UNITED STATES PATENT AND TRADEMARK OFFICE

APPLICATION NO.	FILING DATE	FIRST NAMED INVENTOR	ATTORNEY DOCKET NO.	CONFIRMATION NO.
10/710,713	07/29/2004	Scott D. Maxwell	03-1405 (BOE 0509 PA)	4712
44702	7590	05/30/2006		
OSTRAGER CHONG FLAHERTY & BROITMAN PC 250 PARK AVENUE, SUITE 825 NEW YORK, NY 10177			EXAMINER ROGERS, DAVID A	
			ART UNIT	PAPER NUMBER
			2856

Office Action Summary

DETAILED ACTION

Figure 1

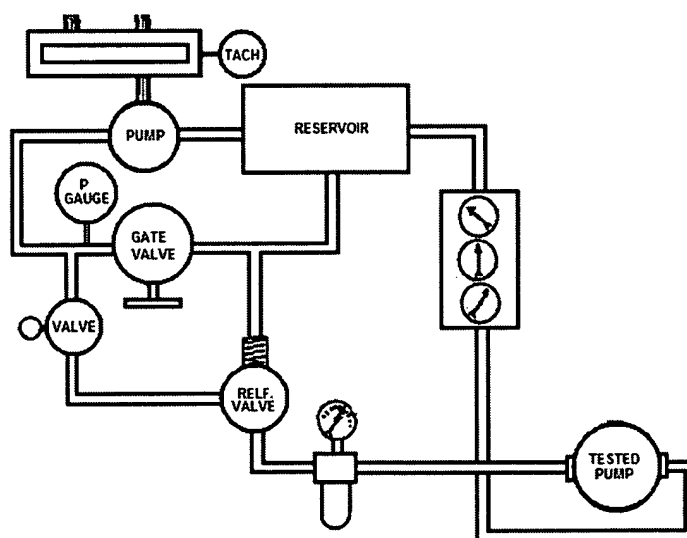
Shepard teaches a method and device for testing hydraulically actuated devices (reference item 56), hereinafter referred to as a device under test (DUT). The general schematic is shown below as figure 1.

The apparatus comprises a first hydraulic fluid reservoir (reference item 32) and a fluid moving pump (reference item 30) that is fluidically coupled to the first hydraulic reservoir. The apparatus also comprises a plurality of pressure gauges (reference items 34 and 50), including an additional pressure gauge on

the flow rater (reference item 68), that can detect the pressures at various points in the hydraulic circuit. As seen in figure 3 there is an indication of the fluid pressure either at reference item 50 or at reference item 68. The flow rater also comprises a temperature sensor for monitoring and indicating the temperature of the hydraulic fluid.

With regard to claim 27 neither chamber will receive hydraulic fluid when the system is in a bypass configuration; i.e., Shepard teaches a bypass configuration where valve 46 is closed and valve 36 is open.

Figure 2

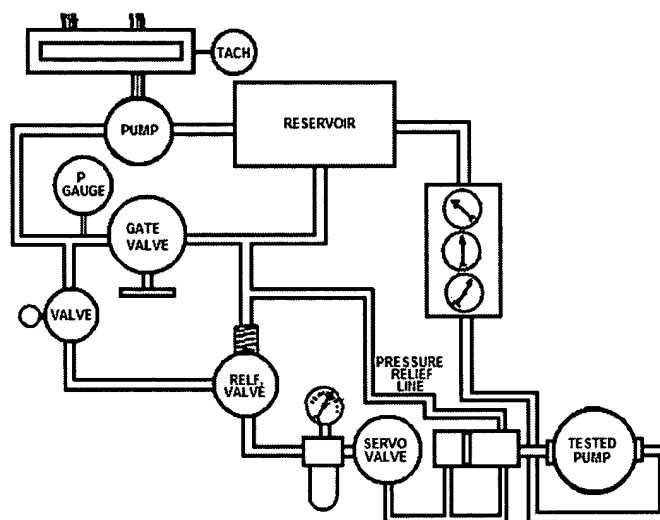
With regard to claims 2 and 3 Shepard teaches a plurality of valves (reference item 36, 46, and 48) for controlling the movement of the hydraulic fluid. These valves inherently separate the tested pump's input hydraulic fluid from its output hydraulic fluid. Furthermore, the servo valve/relief valve arrangement of Beran *et al.* installed after the filter, as noted above, would also control the hydraulic fluid. Finally, adapting the environmental chambers of Brevick *et al.* and/or Phillips to generally surround the servo valve/piston and the DUT would allow only the necessary components to be subjected to the reduced/elevated temperatures. Brevick *et al.* clearly shows

With regard to claim 14 it would have been obvious to add a pressure gauge after the servo valve/piston arrangement shown in figure 2 above so that the test can record the actual pressures used on the DUT.
